| Model: Gim-MF1a/b | | Date: 23-Feb-15 | No.: RM172001 |
| Subject: Service manual revision | | Prepared by: T.Suzuki | |

| Model: Gim-MF1 a/b | | Date: 23-Feb-15 | No.: RM172002 |
| Subject: Troubleshooting - No image printing of received fax | | Prepared by: T.Suzuki | |

LED Lever Operate Decal

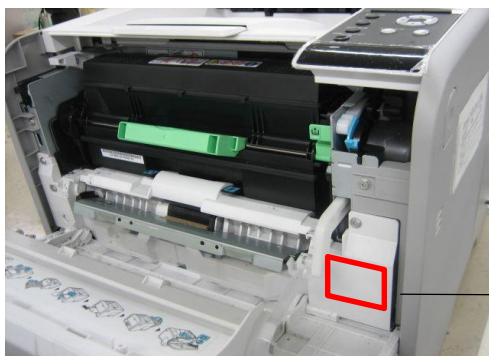
Change: An instructional decal for the LED lever was added.

Reason: To facilitate easier operation of the LED lever.

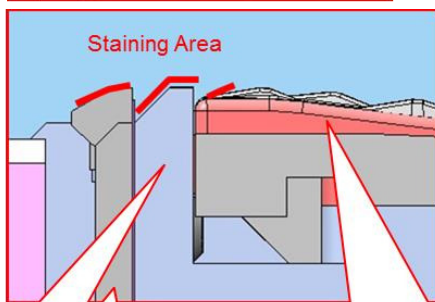
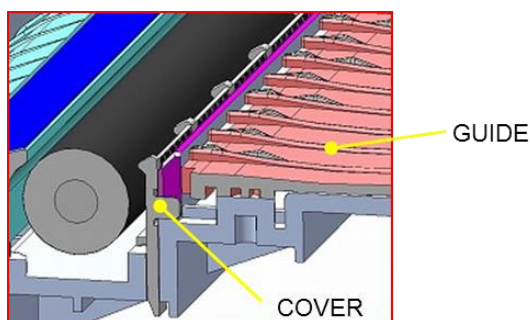
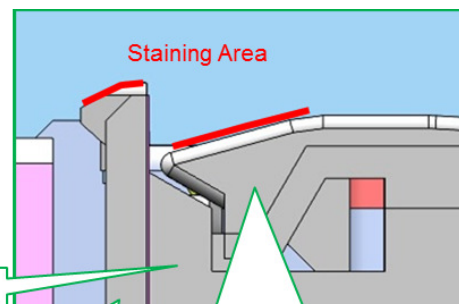
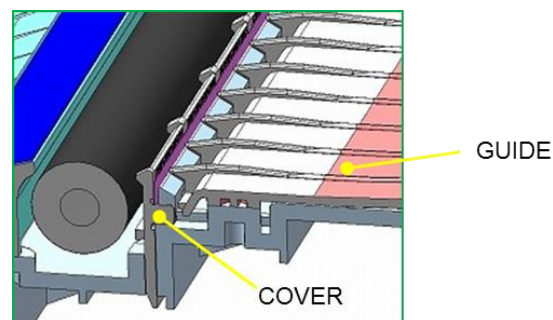
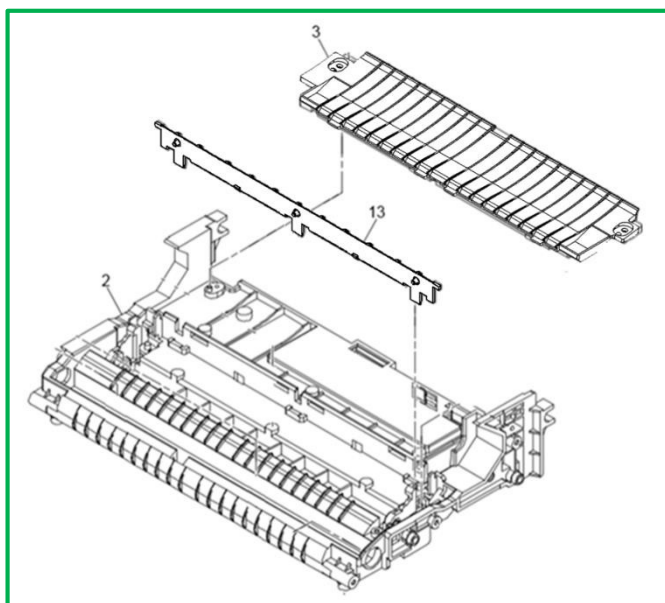
Change: The shapes and/or material of the following parts were changed.

1. The maximum height of the guide rib of the exit guide stay was shortened.
2. The material and shape of the electrode plate cover was changed.
3. The shape of the transfer stay was changed as shown in the illustration.

Note: The reverse side of the printing sheets may get dirty when the sheets pass through the area indicated in the illustration.

Reason: To further minimize staining on the printing paper.

Important: These three parts need to be installed **together as a set**.

19. Fusing Section 1

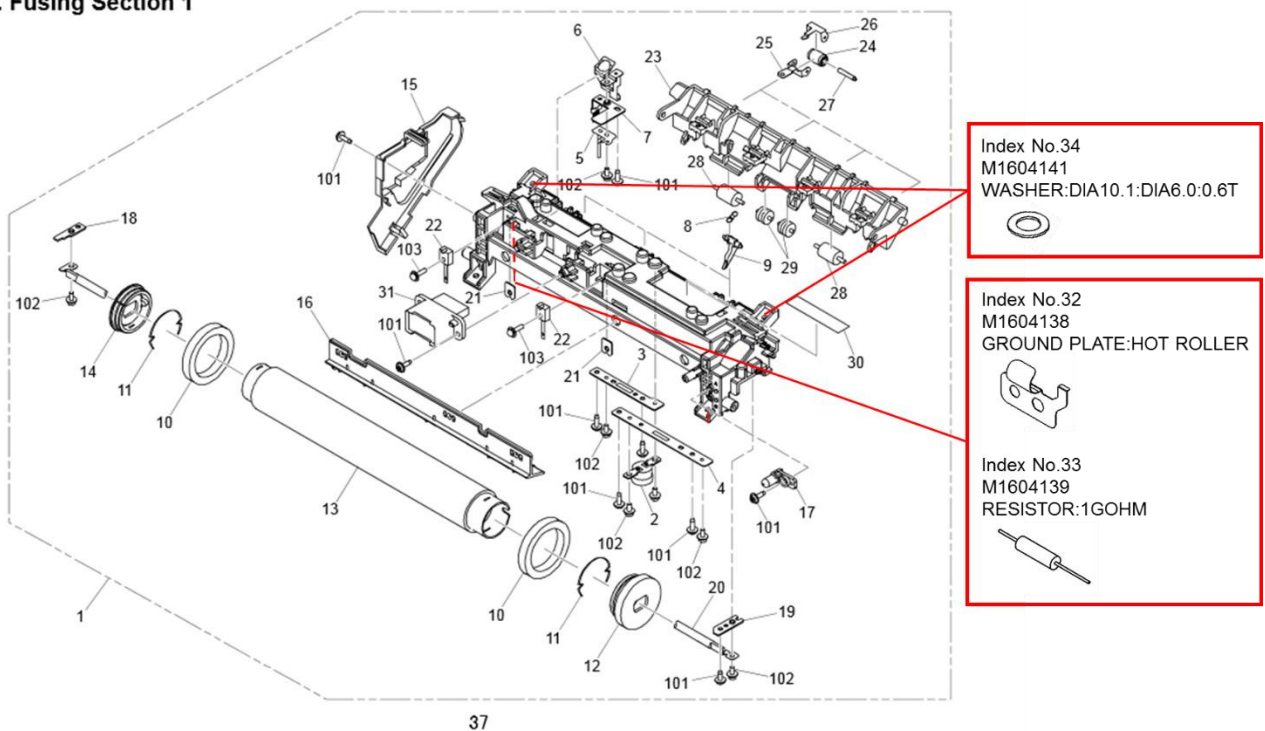
Change: Following parts have been added.

CYN480

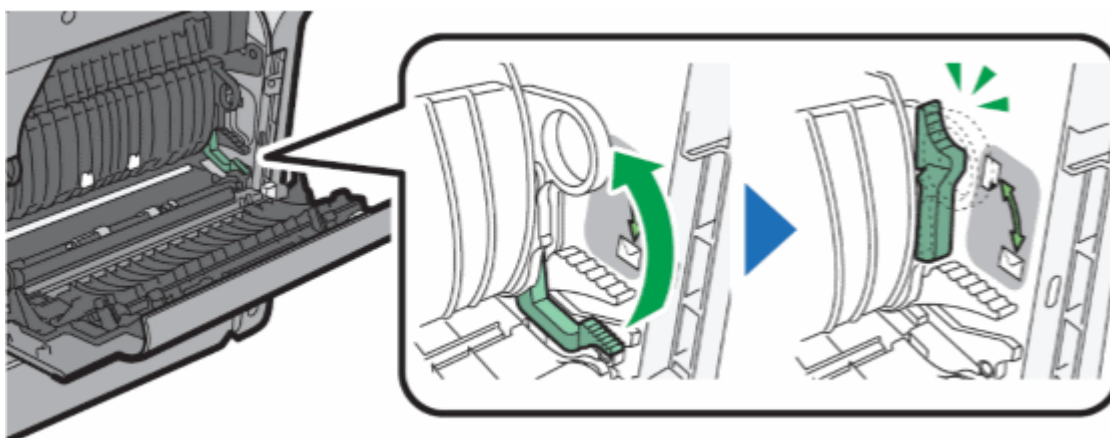
Toner is not properly fixed when printed on a recommended type of plain paper.

The lever is set to the low position for envelope printing.

Raise the lever to the high position.

Lower this lever only when printing on envelopes.

After installing the device or replacing the fusing unit, make sure to raise the lever.

21. Main Frame Section

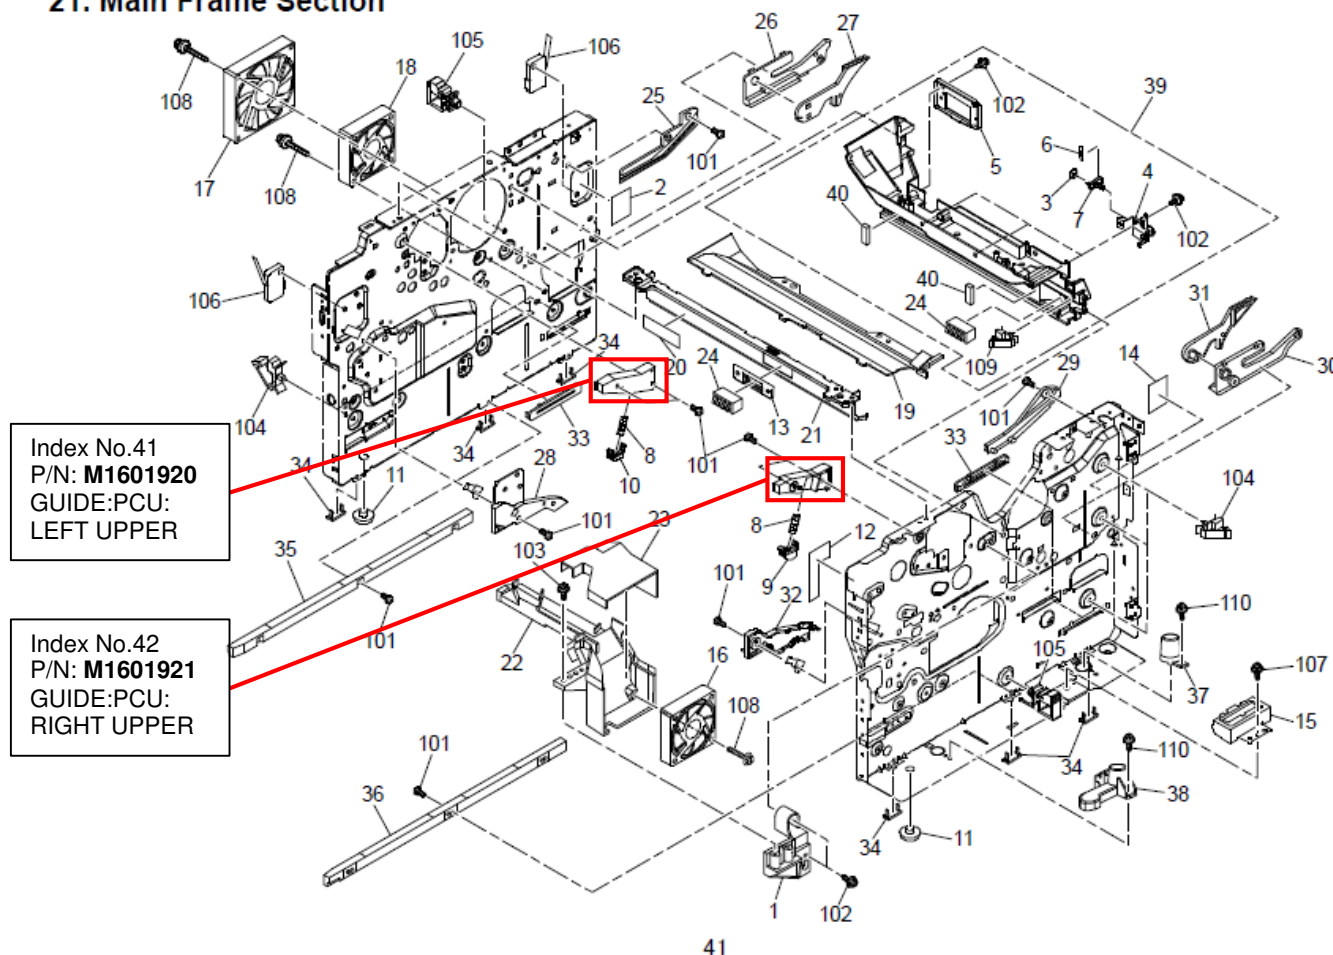
The following parts were registered as service parts.

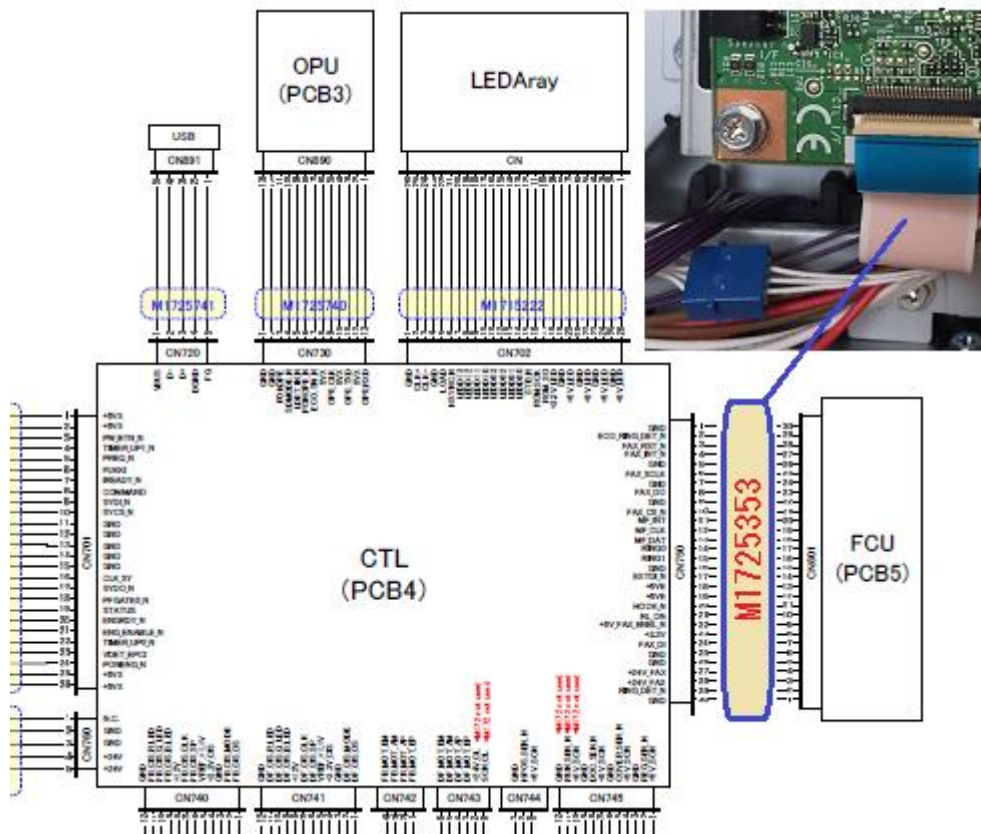
The following part was registered as a service part.

m173m0020

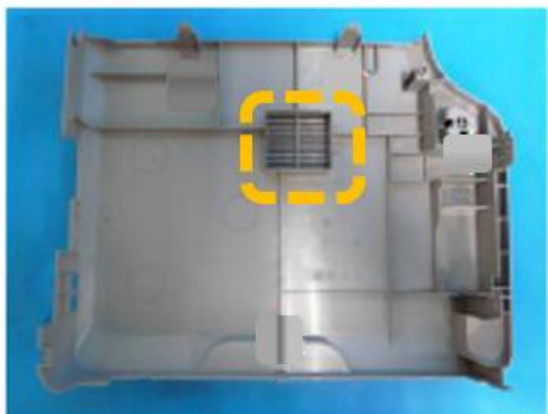
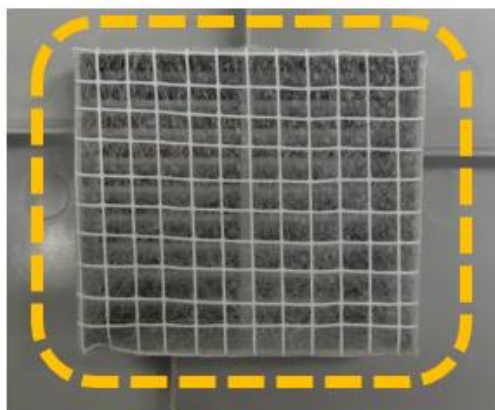
A filter sheet is added to prevent the entry of abnormal substances coming from the intake fan.

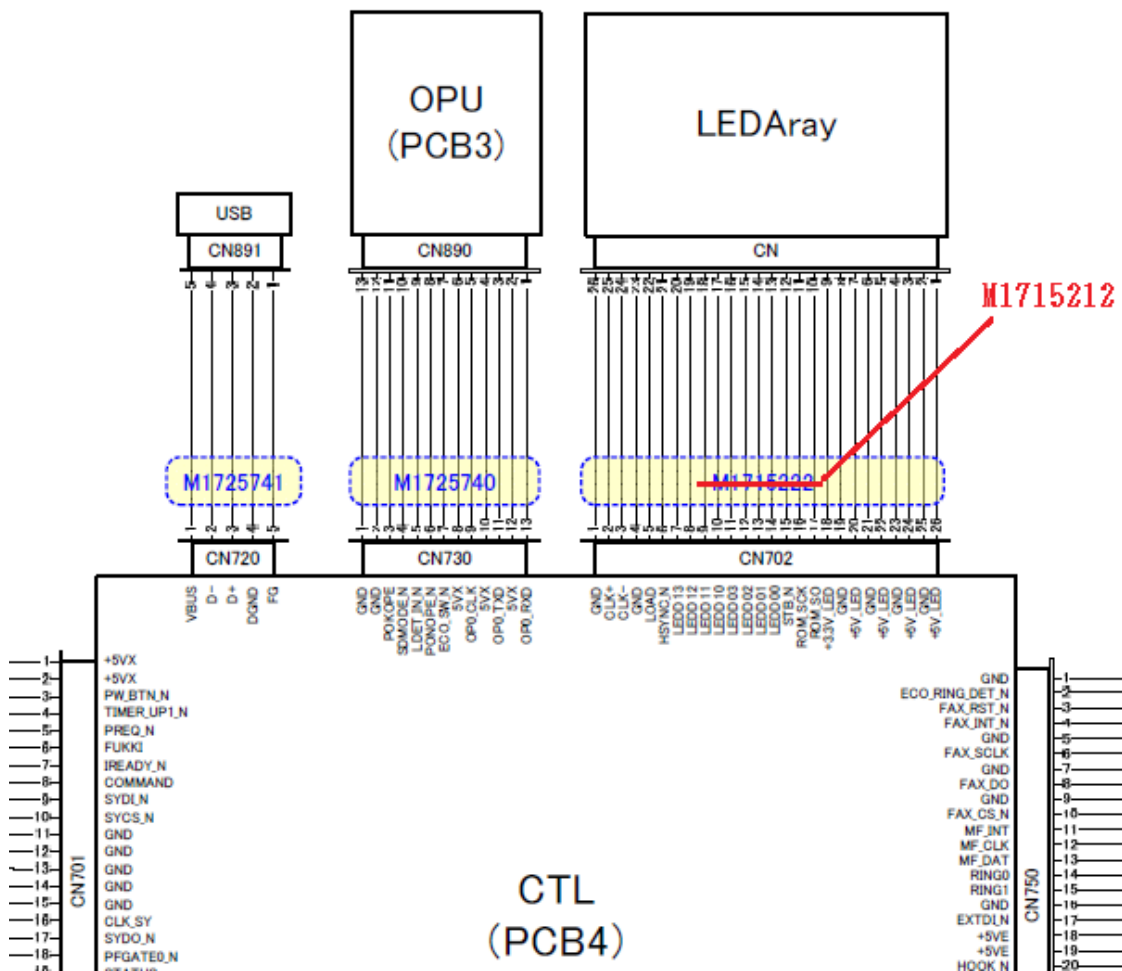
Please correct your part catalog as shown.

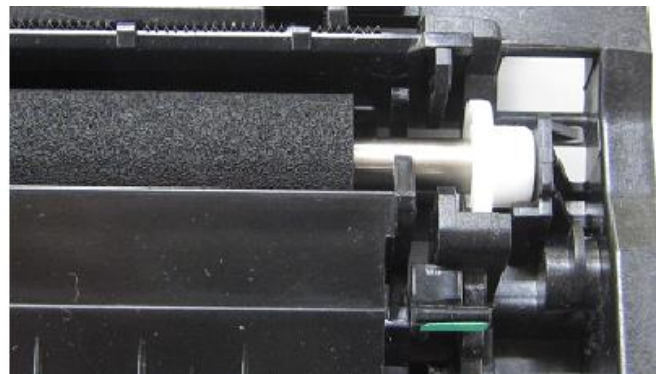
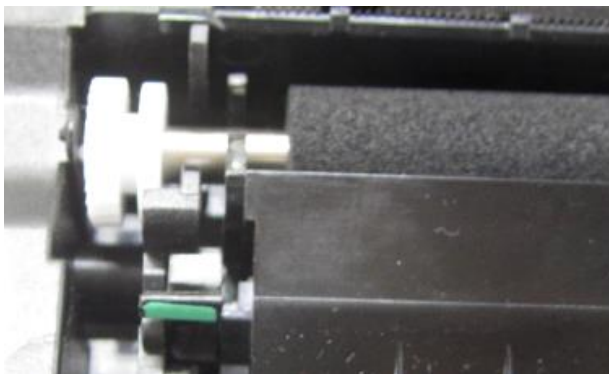
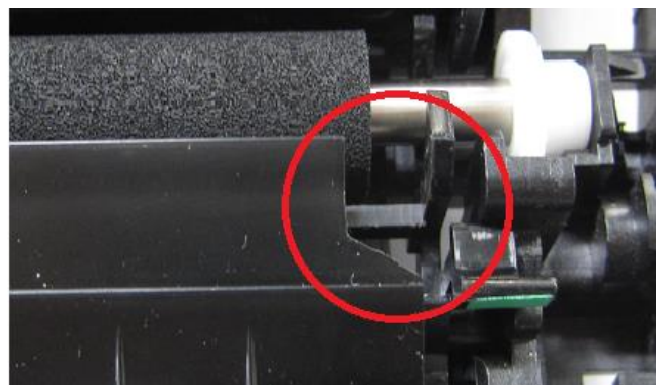
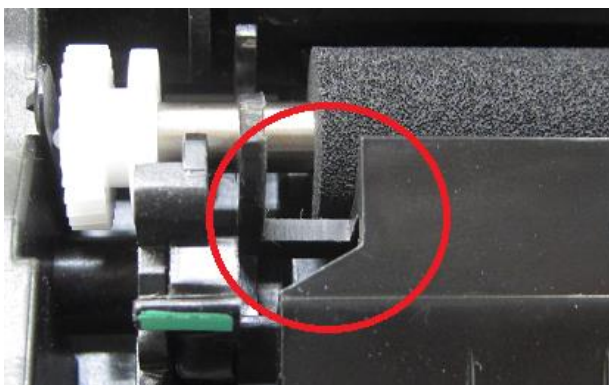
- A cut-out was applied to the right and left edges of the front paper guide of the transfer roller.
- Sponges and sheets were added to the transfer stay.

With this modification, dropped toner goes around the right and left edges of the front paper guide and accumulates on the transfer stay.

This modification has compatibilities. Since the old transfer stay cannot be replaced in the field and the stay of the old type is compatible only with the front paper guide of the old type, when replacing the front paper guide of an old machine, make sure to procure the old type.

This modification allows usage of the PCDU even after exceeding 23K by modifying SP5-931-003*. However, DO NOT modify this SP on machines manufactured prior to this modification, because the front paper guide and transfer stay are both of the old type and will cause toner accumulation on the front paper guide when reaching approximately 23K.

9. Manual Feed Section 2

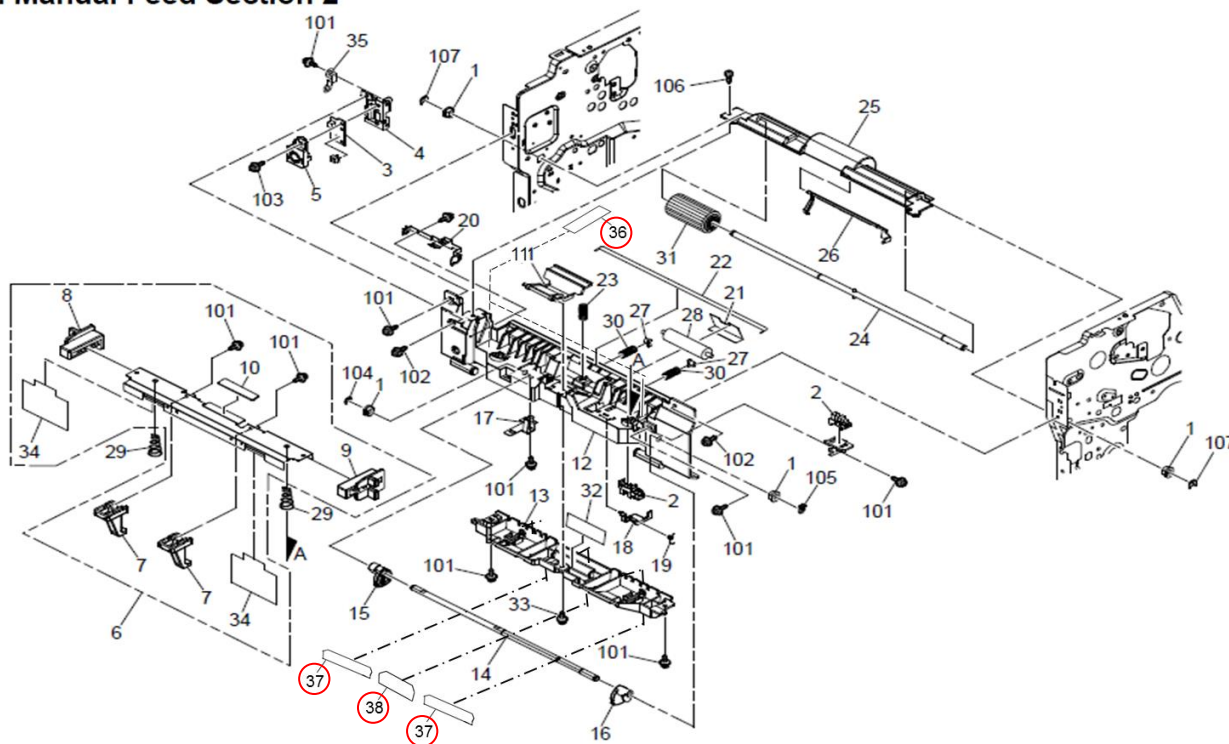
Change: The following parts were registered as service parts.
